Solid Waste Retrieval Complex, Enhanced Radioactive and Mixed Waste Storage Facility, Infrastructure Upgrades, and Central Waste Support Complex, Hanford Site, Richland, Washington

U.S. Department of Energy
Richland, Washington

September 1995

DOE/EA-0981

Figure 2.
Location of Proposed Action - 200 West Area

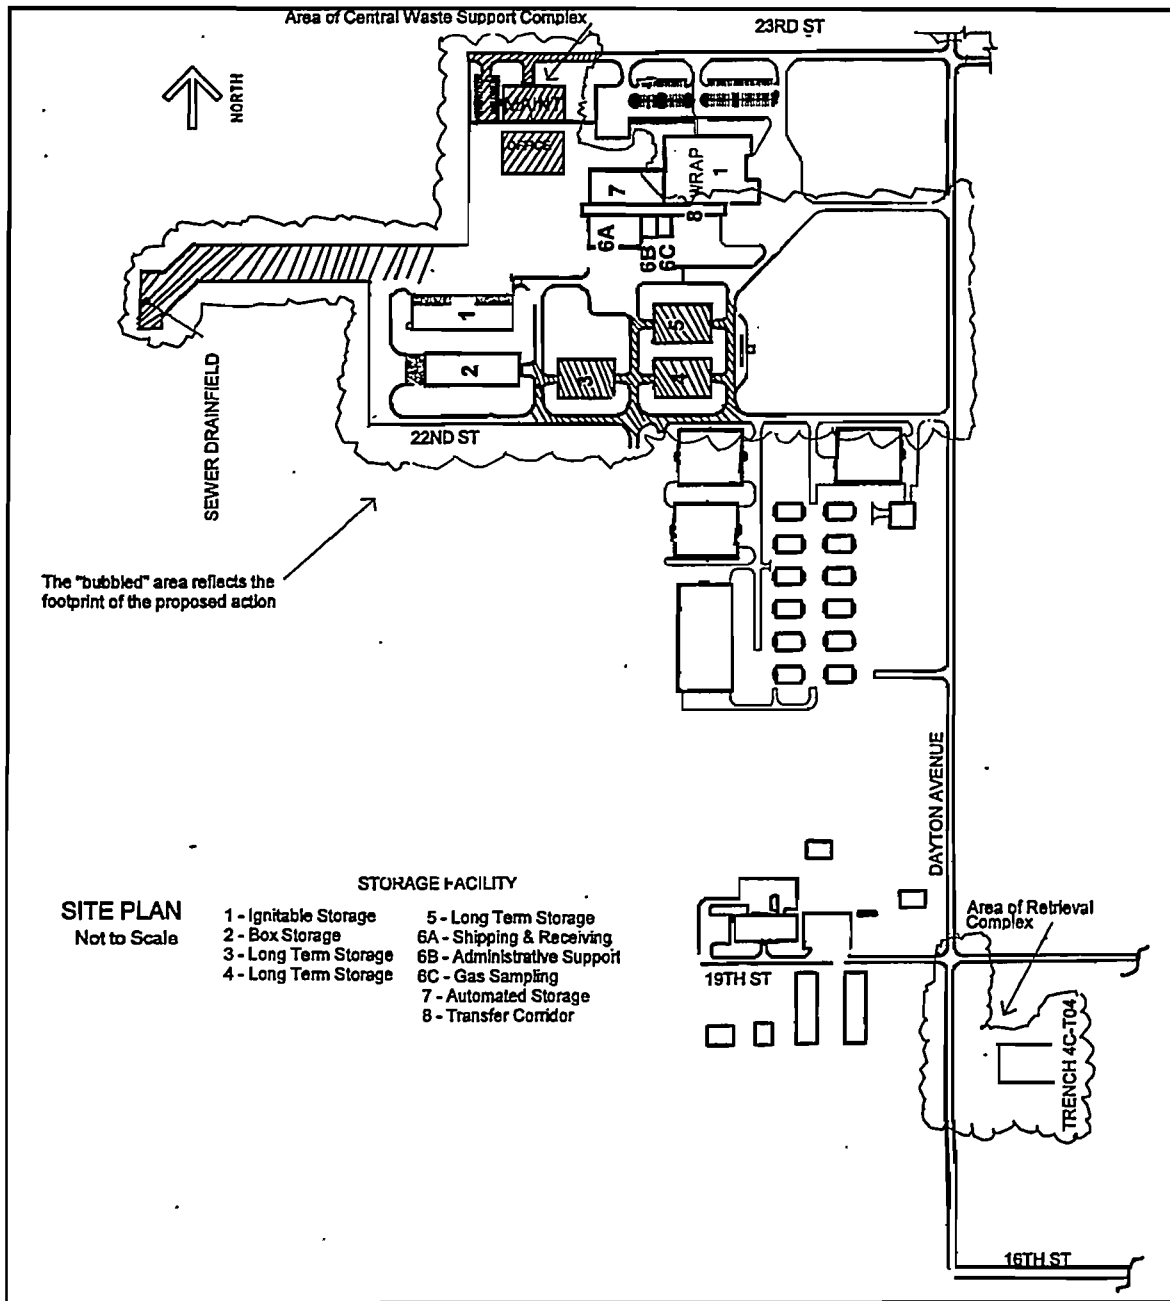
Page 2-1, Section 2.1, first paragraph, fifth sentence. Please clarify where the Retrieval Complex is located, or indicate in Figure 2.

Page 2-3, Figure 2. There are discrepancies between the figure and text regarding the roads, especially 19th St. and Eugene Ave. Batelle's biological survey comments conflict also with the text on page 2-10, bullet starting with "Access Roads". Please refer to Appendix A, underlined paragraph under Project Description. Eugene Ave should not extend south of 22nd St. 19th St. should not extend from proposed Denver Ave to proposed Eugene Ave. Please delete these portions of 19th St. and Eugene Ave. (outside the bubble area which reflects the footprint of the proposed action) from the diagram. If these portions are part of the proposed action, please justify their use. It is apparent that USDOE is planning for future use which may not occur given budget reductions. Unnecessary fragmentation of priority shrub steppe will occur if these road segments are constructed.

Page 2-10, section 2.3, first bullet, fourth sentence. Please clarify the confusion between this sentence and the diagram in Figure 2.

Page 2-10, section 2.3, first bullet , fifth sentence. Please clarify how far 16th and 19th Streets would be extended. These roads should extend no farther than the proposed Denver Ave. to eliminate unnecessary fragmentation of priority shrub steppe. Please include road 16th St. in figure 2.

Comment #6. Page 2-1, Section 2.1, first paragraph, fifth sentence. Please clarify where the Retrieval Complex is located, or indicated in Figure 2.

Comment #7. Page 2-3, Figure 2. There are discrepancies between the figure and text regarding the roads, especially 19th St. and Eugene Ave. Battelle's biological survey comments conflict also with the text on page 2-10, bullet starting with "Access Roads". Please refer to Appendix A, underlined paragraph under Project Description. Eugene Ave should not extend south of 22nd St. 19th St. should not extend south from proposed Denver Ave to proposed Eugene Ave. Please delete these portions of 19th St. and Eugene Ave. (outside the bubble area which reflects the footprint of the proposed action) from the diagram. If these portions are part of the proposed action, please justify their use. It is apparent that USDOE is planning for future use which may not occur given budget reductions. Unnecessary fragmentation of priority shrub steppe will occur if these road segments are constructed.

Comment #8. Page 2-10, section 2.3, first bullet, fourth sentence. Please clarify the confusion between this sentence and the diagram in Figure 2.

Comment #9. Page 2-10, section 2.3, first bullet, fifth sentence. Please clarify how far 16th and 19th Streets would be extended. These roads should extend no farther than the proposed Denver Ave. to eliminate unnecessary fragmentation of priority shrub steppe. Please include road 16th St. in figure 2.

Response: A note will be placed on Figure 2 adjacent to Trench 4C-T04 to indicate the "Retrieval Complex".

Response: The text on page 2-10, Access Roads, will be clarified to note that the 16th, 19th, 22nd, and 23rd St. road extensions would be "west of Dayton Avenue to Denver Avenue" as reflected in Figure 2. Eugene Avenue south of 22nd Street and 19th Street west of Denver Avenue will be removed from Figure 2 since they do not now exist and are not part of the proposed action.

Response: See response to comment 7.

Response: See response to comment 7. In addition, 16th Street will be added to Figure 2 (similar to 19th Street) ending at Denver Avenue.
